# **Mechanical, Electrical & Plumbing Review Process Webinar**

Presentation to Port Authority External TCAP Community

07.16.2025

TABLE 403.3.1.1 MINIMUM VENTILATION RATES

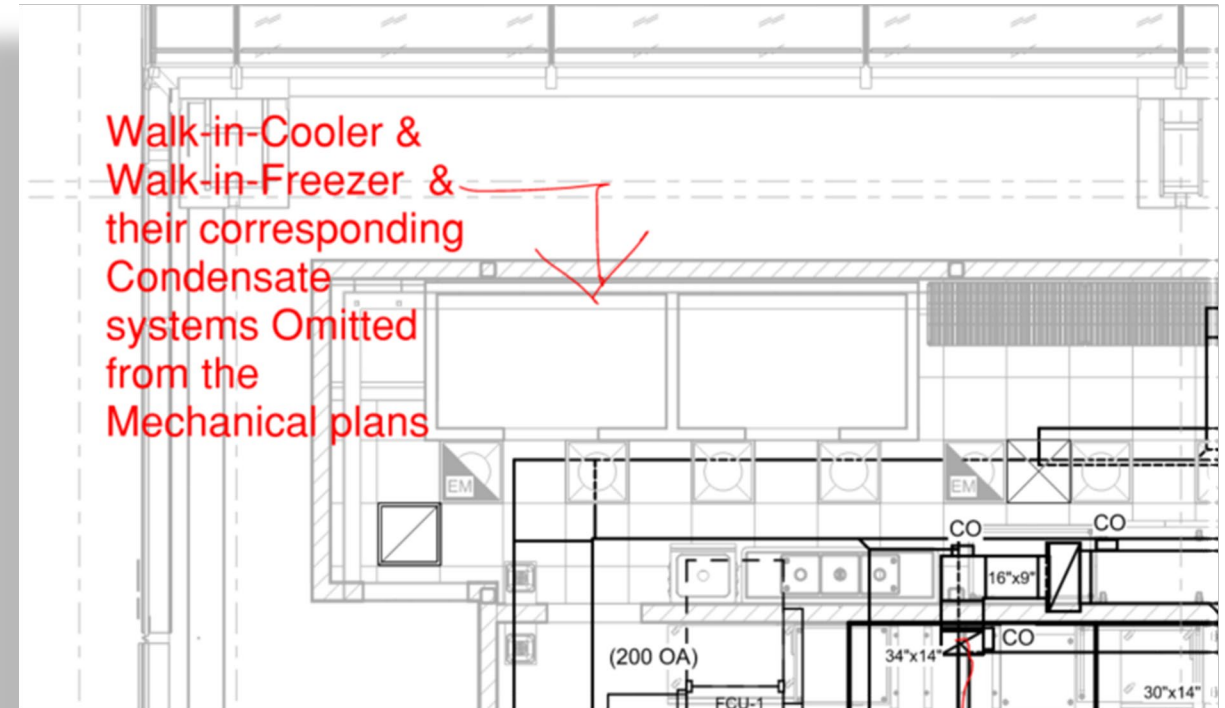
**Issue: Ventilation Calculations are omitted when changes or additions to HVAC system are made. Also, toilet and shower rooms are omitted from the calculations.**

**QAD Comment: Provide ventilation calculation as per 2022 NYC Mechanical Code, Table 403.3.1.1.**

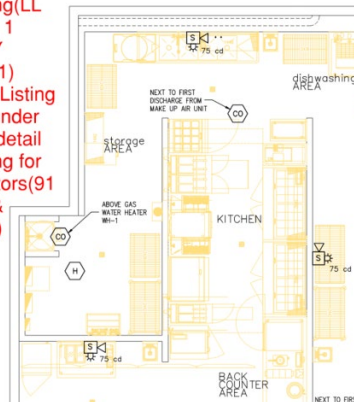
1. Visual Notification Appliances Missing(LL 126 & 1 RCNY 915-01)
2. UL Listing & Sounder base detail missing for detectors(915.1.2& 915.6)

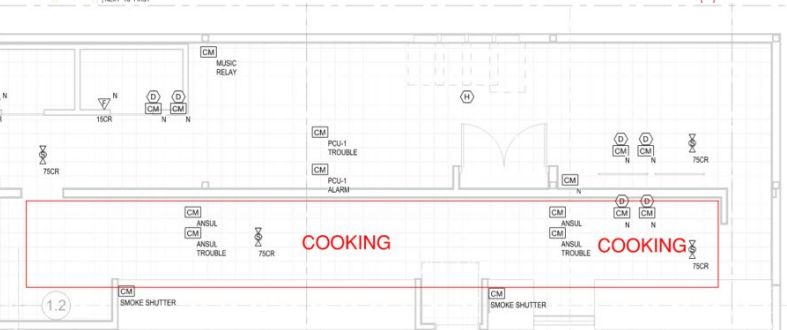
Only one CO detector on the far end of the room, while cooking takes place on the opposite side(915.1.2)

Drawing 1 – Gen Removal

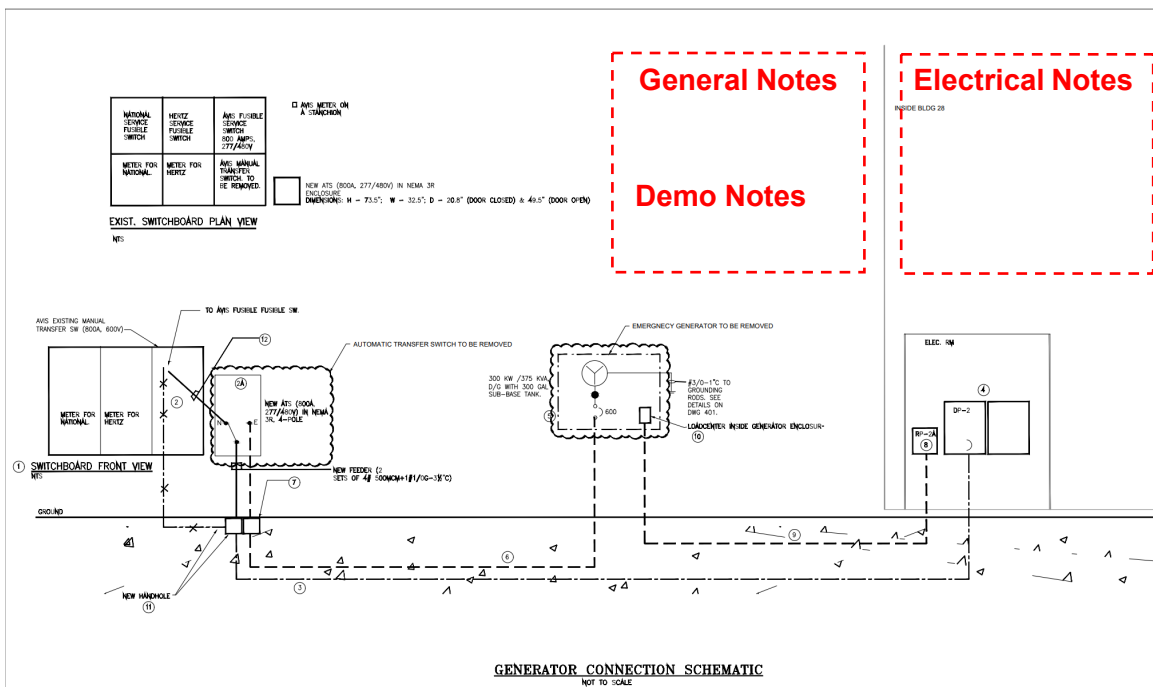
No Demolition Notes

No Electrical Notes

No, in compliance with the 2023 Sections; 2.1 & 10.

No, in compliance to AHJ
